6795B **County Permit Review Worksheet** 1418

IMPROVEMENT PERMIT for a RESIDENTIAL ON-SITE WASTEWATER TREATMENT & DISPOSAL SYSTEM

GWS Septic System Design Review

RE: Request for an Improvement Permit for Lot 57 off of Sample Road at The Retreat at Latta Plantation
MCHD File #6795B

Scale: 1 inch equals 50 feet	S&ME	Faison - Sample Road LLC	FIGURE
Drawn by: JBP		Lot 57	1
Reviewed by: TCJ		Mecklenburg County, NC	
Date: June, 2007	ENVIRONMENTAL SERVICES • ENGINEERING • TESTING	S&ME Project #1588-05-091

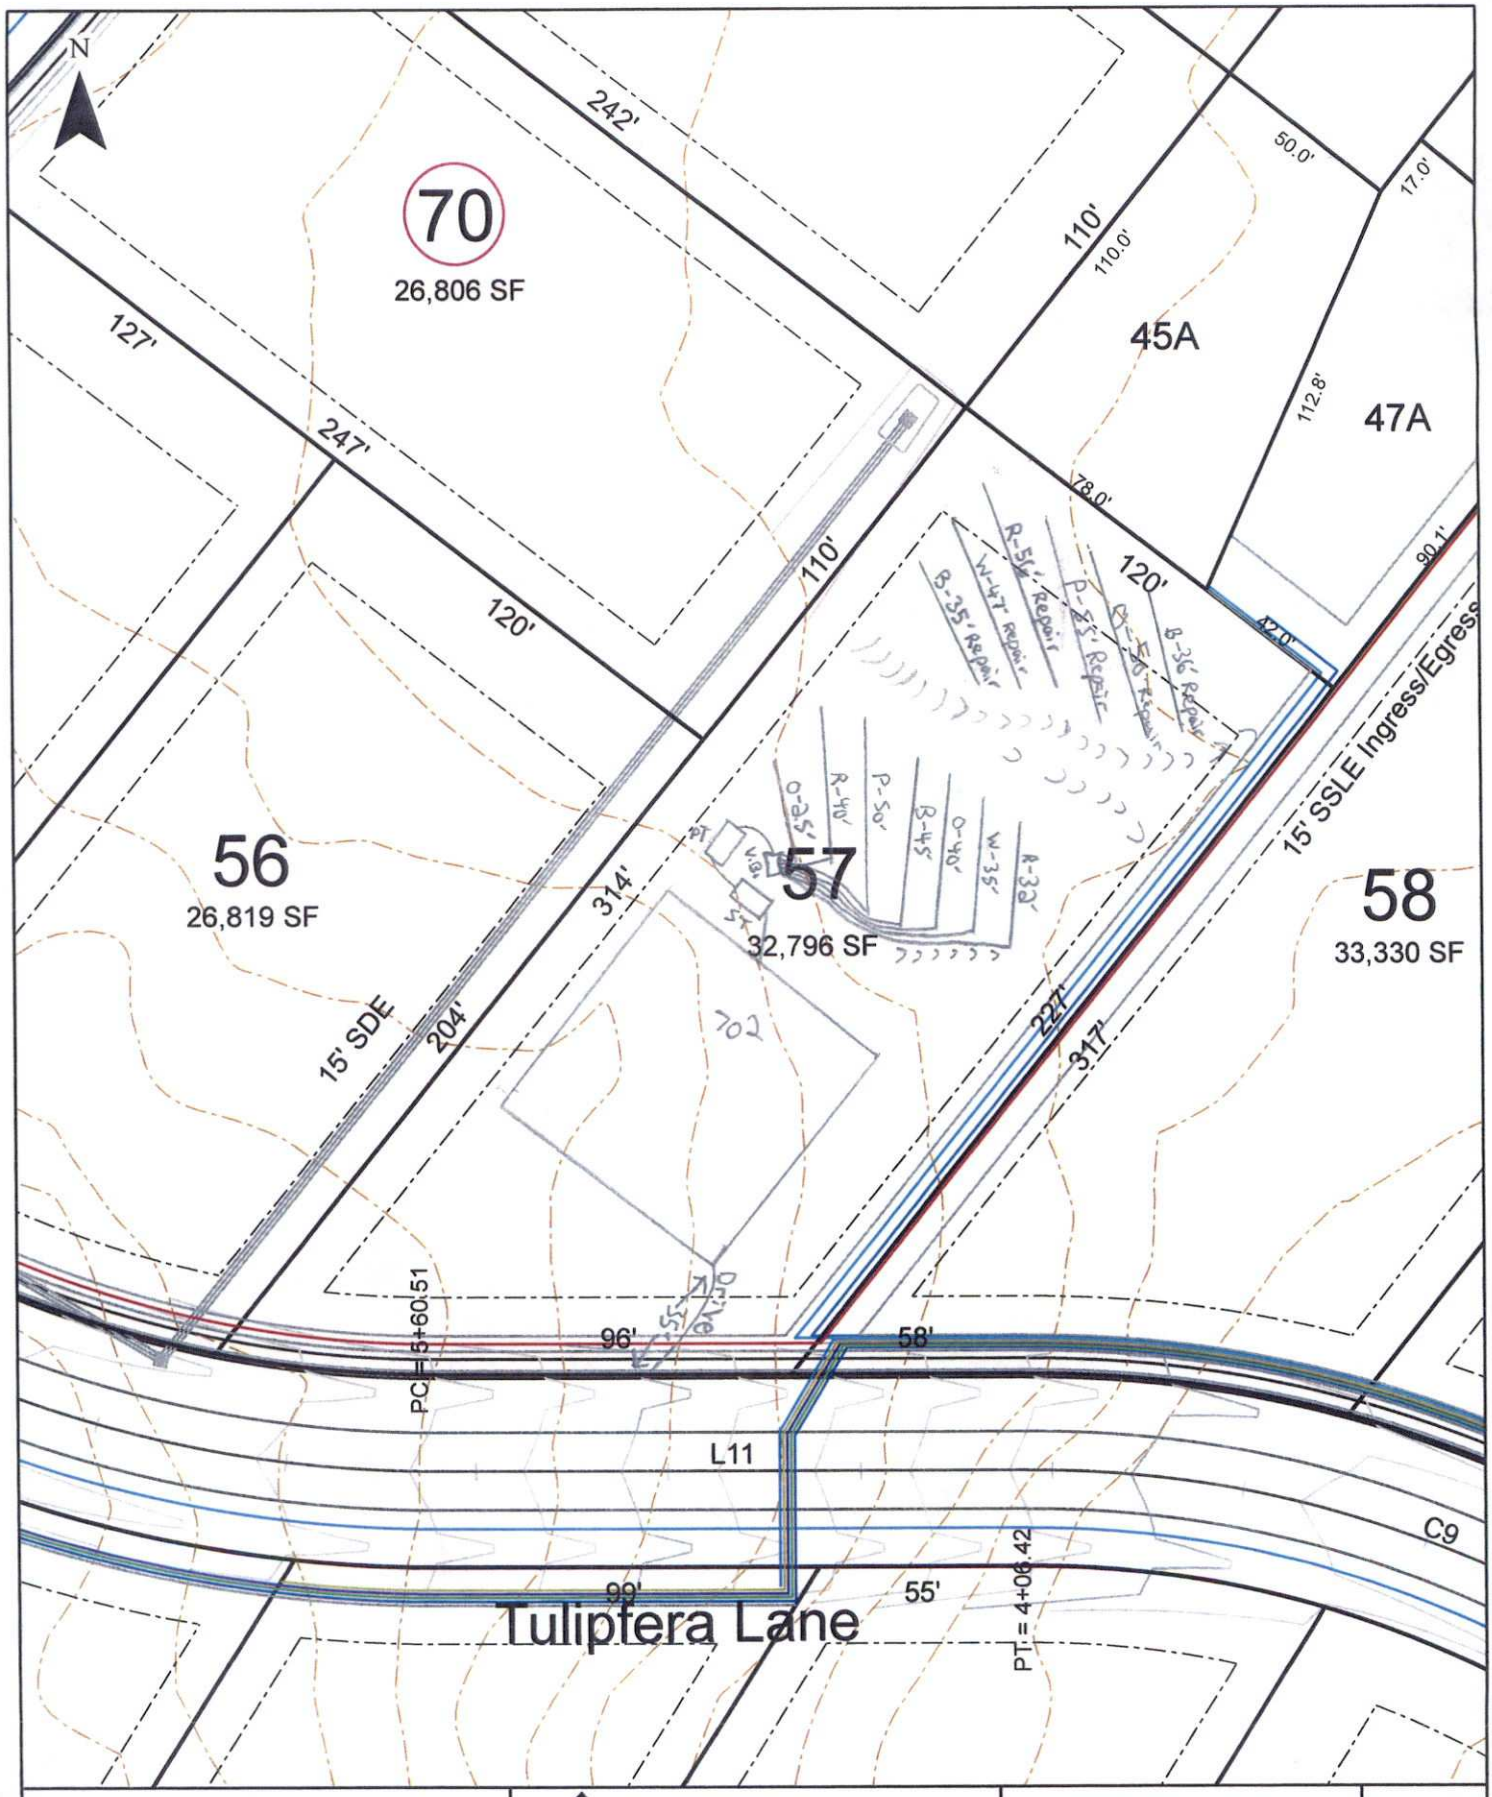
The proposed system is a TYPE IV and will require a contract with a Certified Operator to supply maintenance services for the septic system. Please review the attached system sketch and design specifications for the Improvement Permit. If necessary, the MCHD may add comments to the site plan or specifications. Please call if you have any questions or comments.

GWS File #: 6795B	**Approved**	**Disapproved**
Design Review: TCT 6-18-07	☒	☐
Field Review: 6/19/07	☒	☐
